Building Permit Application

Permit No.: B19001587

Subject: Project name WALSMAN RESIDENCE
Project site address 1834 ~~WALSMAN RD~~ Long Corner Rd
Permit # B19001587 SDP # _____
Other information pertinent to this project re-submit plans

REMODELING OF THE RESIDENCE OF
 DAN AND DIONNE WALSMAN
 1834 LONG CORNER RD. MT. AIRY, MD

EXISTING BASEMENT FLOOR PLAN
SCALE: 1/4" = 1'-0"

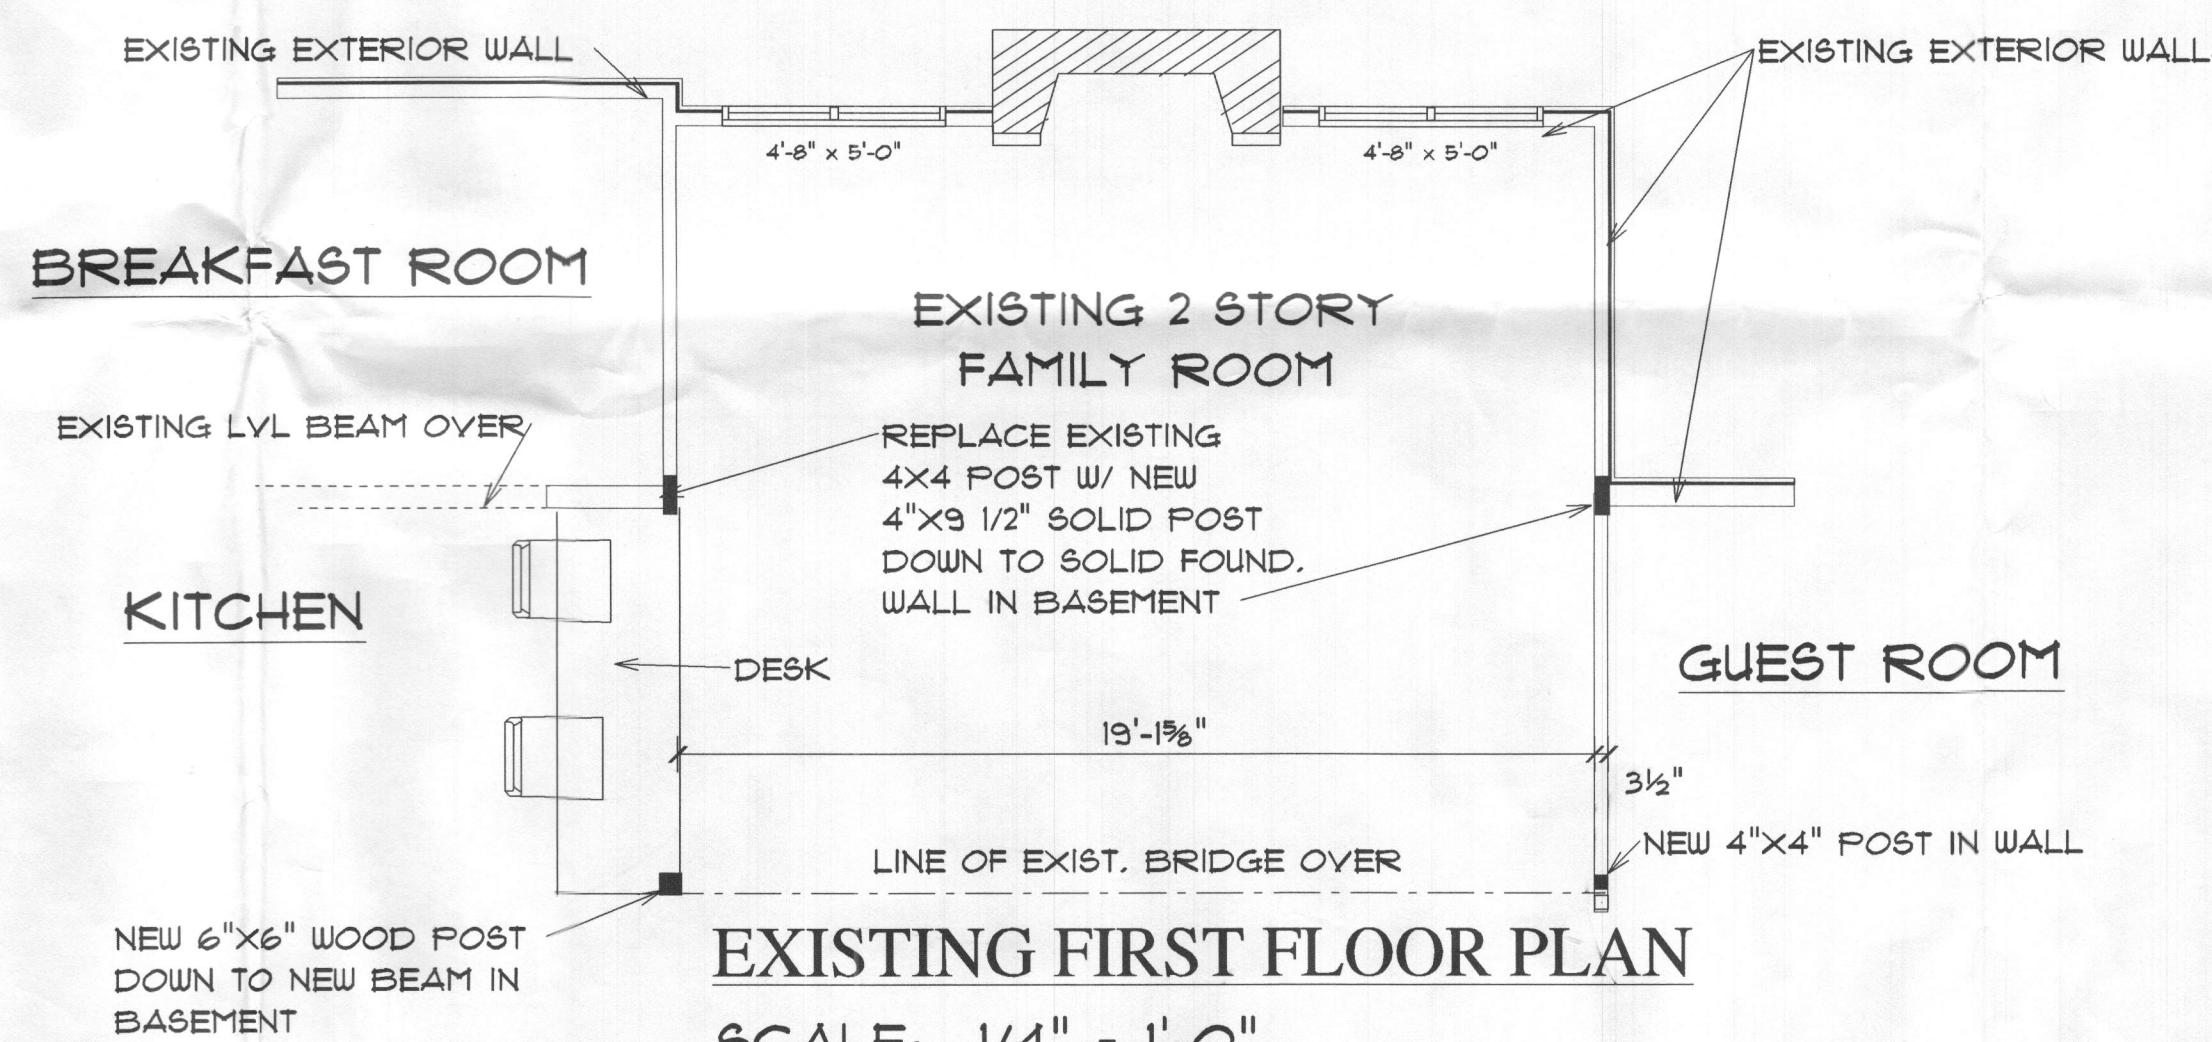
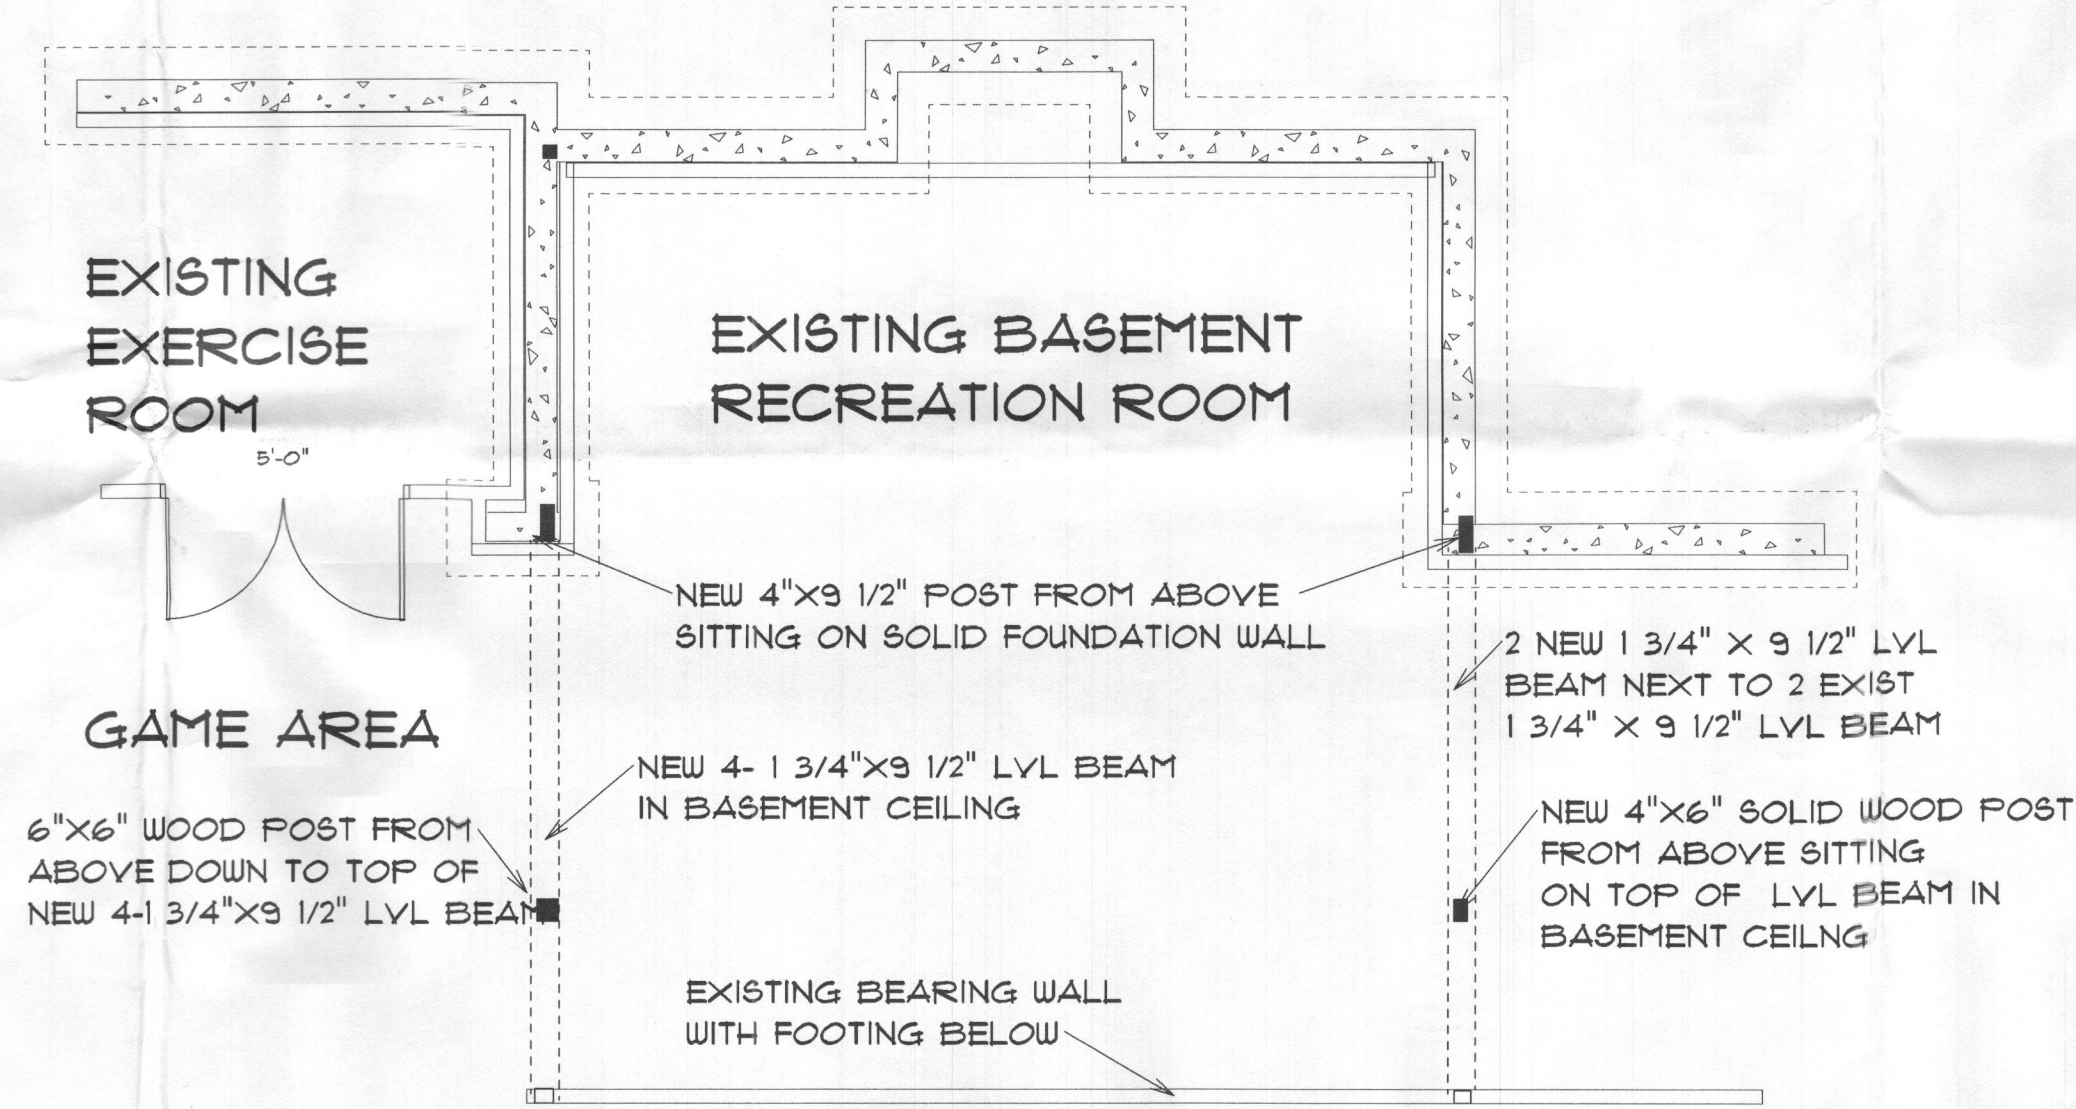
Approved Septic System Plan
Howard County Health Department
Game Rm w/ 2-PC Bath (Powder Rm)
and Laundry included approved on 1/27/2019
a new existing Living Rm.
R. Hurst
B19001587
1834 Long Corner Rd.

REVISED
Date: 6/14/19
Comments: B19001587
CHANGE FB TO HB
